Access Compliance Report

Public Rights-of-Way

Intersection ID: 2865	Main Street: DOWNFIELD_WOOD_DR	Cross Street: LADY_BANK_DR	Location: S
ADA ID: 485ED8146BB7	Ramp Type: Perp	Initial Pass/Fail: Fail	Overall Compliance: No
Codes/Mitigation Info/Possible Solution		Field Measurements/Component Compliance	
Severity Score: 26.25

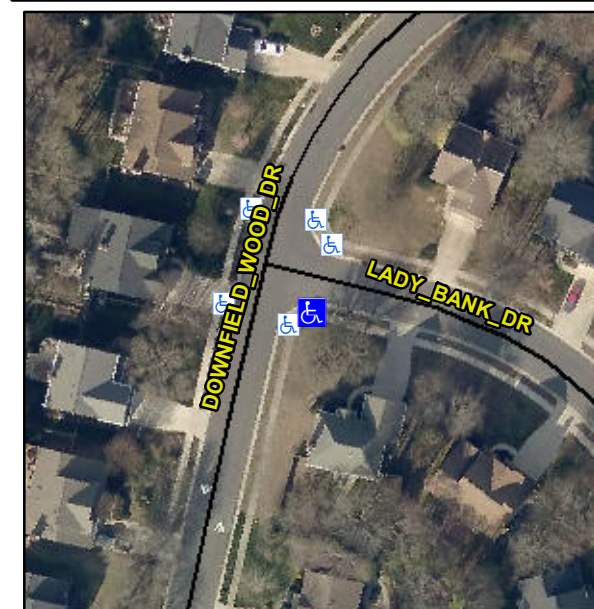
R304.2.2, R304.5.3

Compliance	Description	Data	Compliance	Description	Data
N/A	Ramp Length (in)	47.0	No	Ramp Slope (%)	15.0
Yes	Ramp Width (in)	48.0	No	Ramp XSlope (%)	3.2
N/A	Flare Type LT	N/A	N/A	Flare Type RT	N/A
N/A	Flare Slope LT (%)	N/A	N/A	Flare Slope RT (%)	N/A
N/A	Flare Traversable LT?	N/A	N/A	Flare Traversable RT?	N/A
N/A	Landing Length (in)	N/A	N/A	DWS Provided?	N/A
N/A	Landing Width (in)	N/A	N/A	DWS Contrast?	N/A
N/A	Landing Slope (%)	N/A	N/A	DWS Length (in)	N/A
N/A	Landing X Slope (%)	N/A	N/A	DWS Full Width?	N/A
N/A	Landing Curb? (Y/N)	N/A	N/A	DWS Offset (in)	N/A
N/A	Shared Landing?	N/A			
N/A	Gutter Ponding?	N/A	N/A	Gutter Slope (%)	N/A
N/A	Gutter Lip Ht (in)	N/A	N/A	Gutter X Slope (%)	N/A
N/A	Painted X Walk1?	No	N/A	Painted X Walk2?	N/A
	X Walk 1 Direction	To NE		X Walk 2 Direction	N/A
N/A	X Walk 1 Width (in)	N/A	N/A	X Walk 2 Width (in)	N/A
	X Walk 1 Slope (%)	2.4		X Walk 2 Slope (%)	N/A
	X Walk 1 X Slope (%)	2.6		X Walk 2 X Slope (%)	N/A

Remove & Replace Entire Ramp.
